Service Bulletin

SG1400C3 ~ SG1800C3 Transformer/Bracket Installation

Product Group: Power Solutions	Date Issued: 11/05/12	Service Bulletin No. GSP20121105
Bulletin Type ☒ Mandatory ☐ Information Only ☐ Recommended Change		Models/Series Affected: SG1400C3 ~ SG1800C3 S/N MX170654 ~ WA578213

Figure 1. Transformer Kit

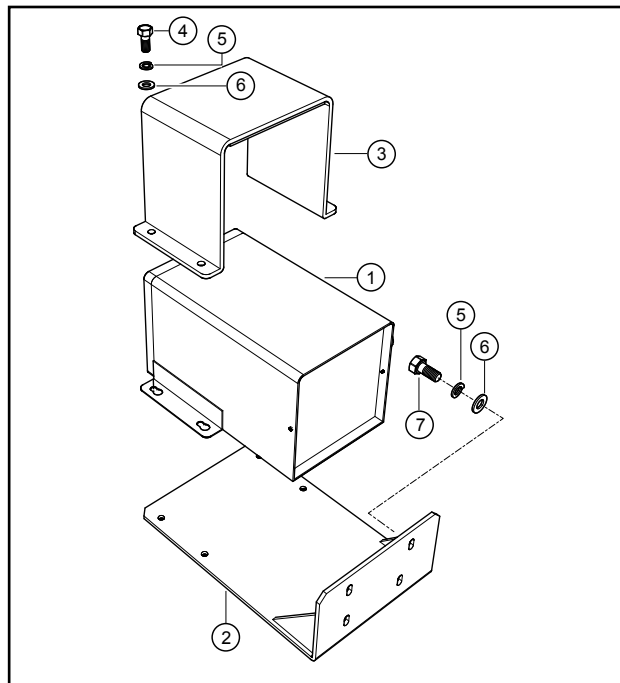
Existing saddle box transformer mounting surface is not adequate to support transformer.

Relocate and mount transformer onto cabinet floor.

Item No.	Part No.	Description	QTY.	Remarks
1	EE55799	Transformer	1	If Required
2	EE56737	Bracket (Floor)	1	
3	EE56719	Bracket (Hat)	1	
4	N/A	Bolt 3/8" X 1"	4	
5	N/A	Washer, Lock 3/8"	8	
6	N/A	Washer, Flat 3/8"	8	
7	N/A	Bolt 3/8" X 1-1/4"	4

Figure 3. Transformer Removal

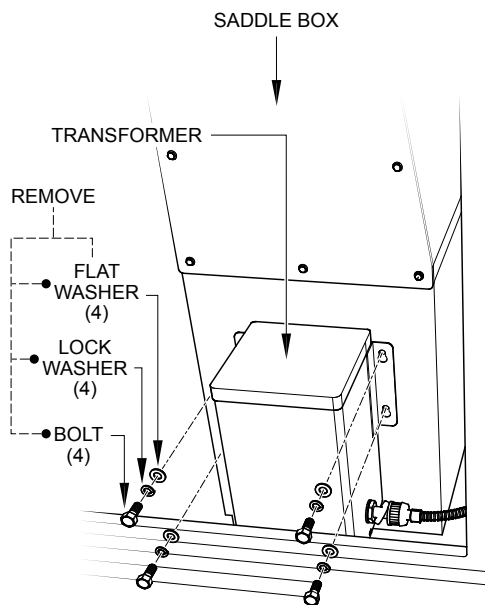
2. Remove the existing mounting hardware (Figure 3) that secures the transformer to the saddle box. Discard mounting hardware, they will not be used again.

Figure 4. Installing Transformer Mounting Brackets (Hat/Floor)

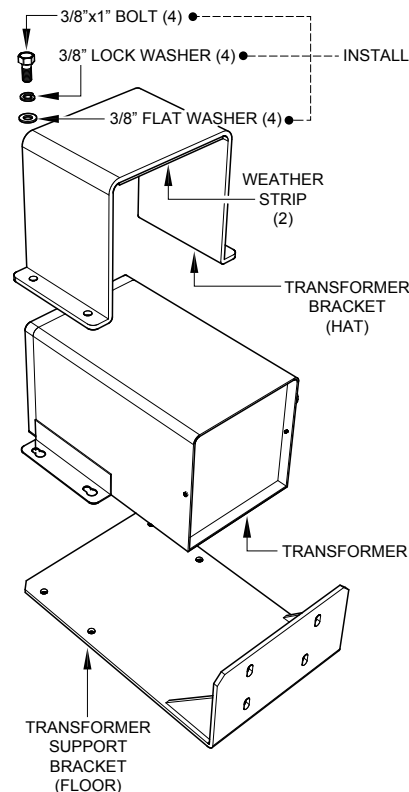
1. Align transformer bracket (hat) with transformer mounting ears along with transformer support bracket (floor) as shown in Figure 4.
2. Secure both brackets (Figure 4) to transformer using a 3/8" x 1" bolt (4), 3/8" lock washer (4), and 3/8" flat washer.

Figure 7. Mounting Transformer To Cabinet Floor

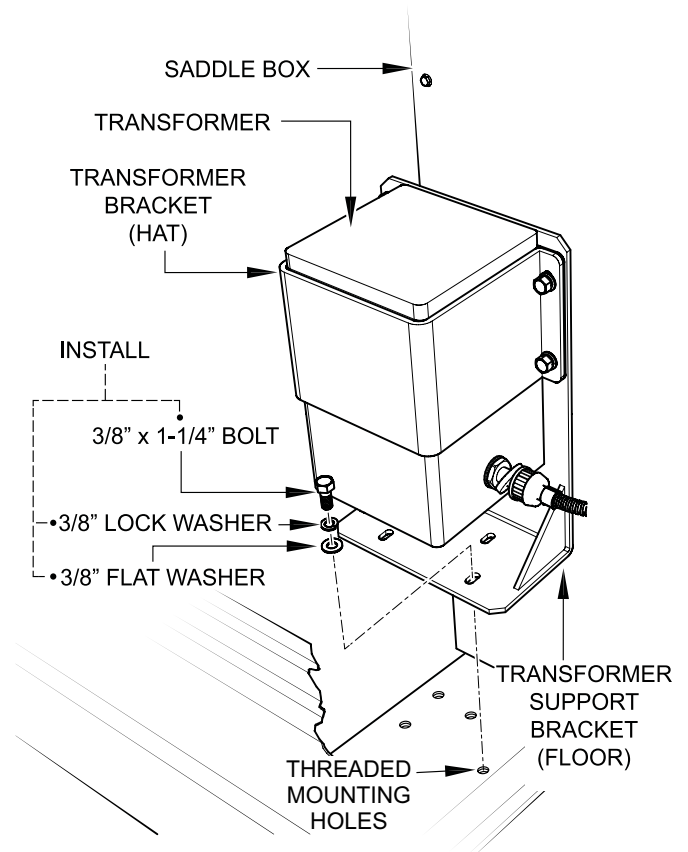
4. Align transformer support bracket with the threaded mounting holes on cabinet floor as shown in Figure 7
5. Secure transformer bracket (floor) to cabinet floor using a 3/8" x 1-1/4" bolt (4), 3/8" lock washer (4), and 3/8" flat washer.

Figure 11. Wiring Connections

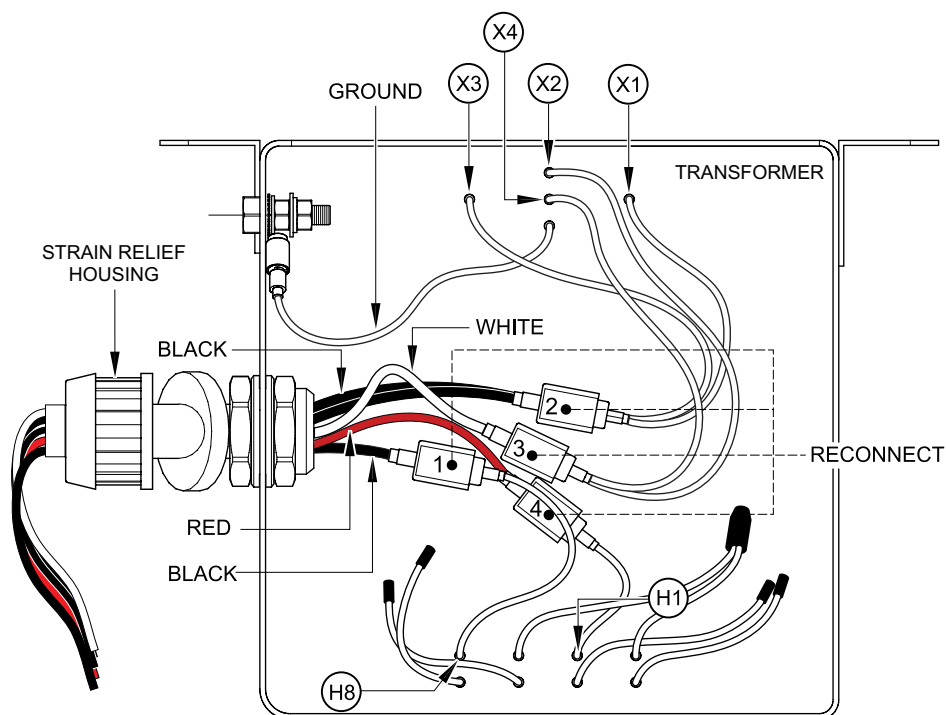
- Route all the strain relief cable wires through the hole opening on the **new** transformer.
- Insert all strain relief cable wires through plastic locking nut. Secure strain relief housing with plastic locking nut.
- Reconnect all strain relief cable wires (4) as shown in Table 1 and Figure 11.

Transformer Side		Strain Relief Side
Ref. Des.	COLOR	COLOR
H1	WHITE (single wire)	RED
H8	WHITE (single wire)	BLACK ((single wire)
X3-X1	WHITE (dual wire)	BLACK (dual wire)
X2-X4	WHITE (dual wire)	WHITE (single wire)
